CERTIFICATE OF APPROPRIATENESS

Applicant: Alexander Ridgway, Brickmoon Design, LLC for Tomas and Theresa Pavia, owners

Property: 1518 Columbia Street, lot 17, block 136, Houston Heights Subdivision. The property includes a historic 1,343 square foot, one-story wood frame single-family residence and a detached garage situated on a 6,600 square foot (50' x 132') interior lot.

The applicant now proposes to, in addition to previously approved scope of work, raise the residence by 8", from a finished floor height of 1'-9" to 2'-5".

**NORTH SIDE ELEVATION**

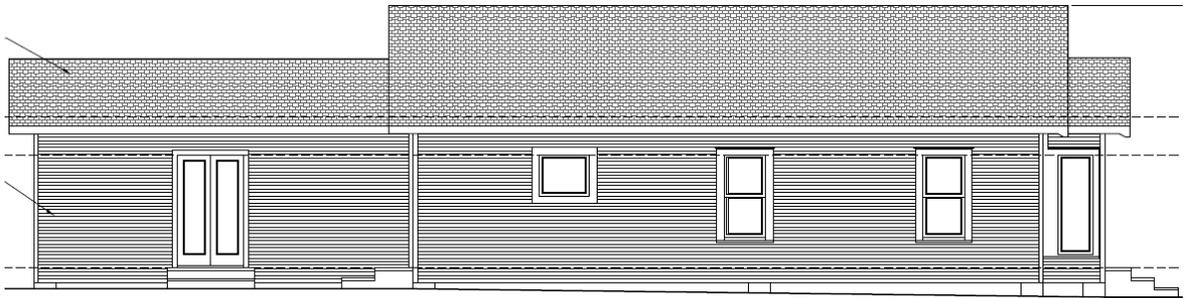
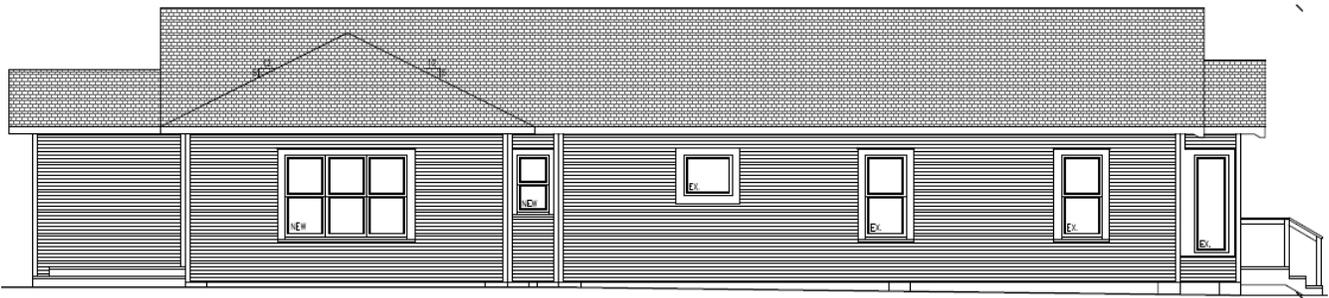
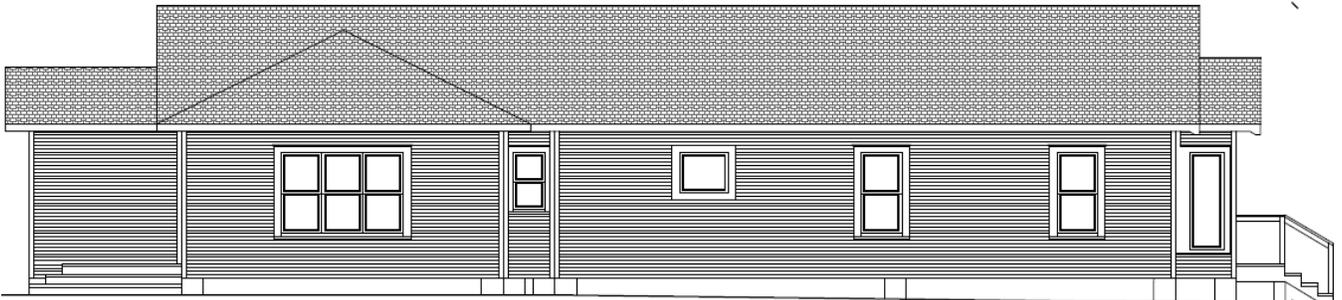
**Side Elevation:** The residence features one fixed window to remain in the enclosed front porch and two double (North) hung windows and one casement window to remain. The existing rear addition features a pair of doors to be removed. The proposed addition will begin at the original back wall and feature a single window and a ribbon of three windows.

**SOUTH SIDE ELEVATION**

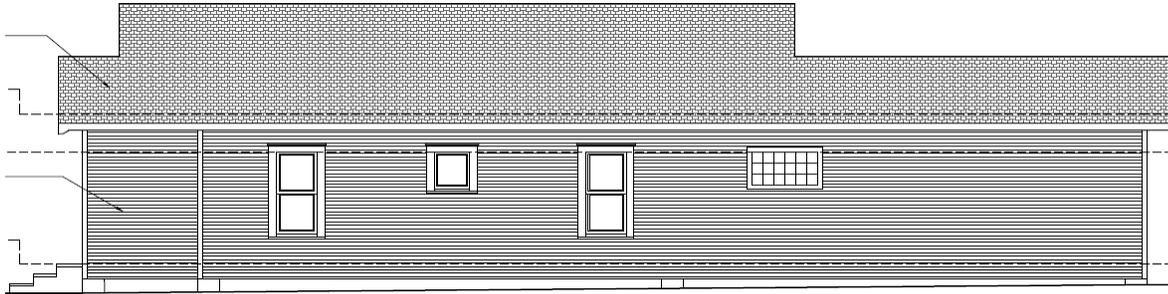
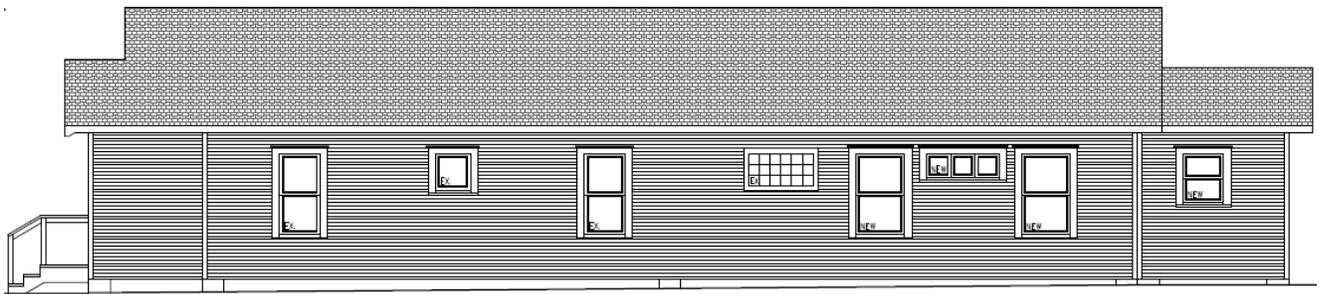
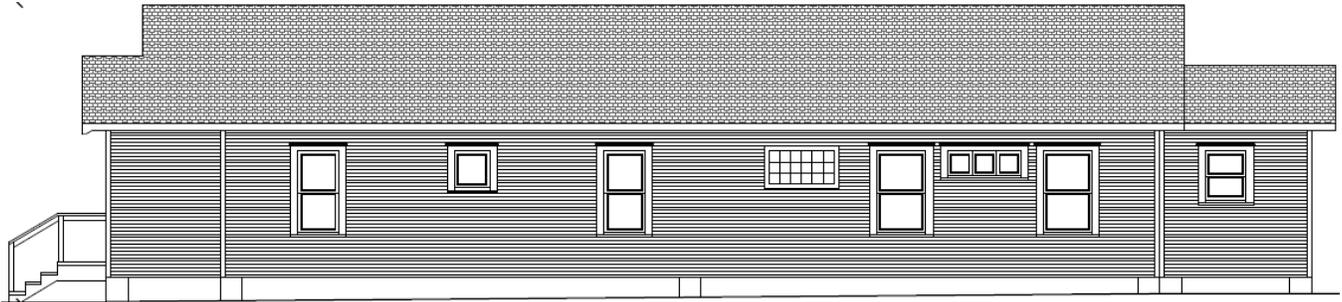
**Side Elevation:** The residence features two double hung windows, one fixed window and one glass block window, (South) all to remain. Two new double hung windows and a ribbon of three fixed windows will be installed in the existing addition. The proposed addition will feature one double hung window.
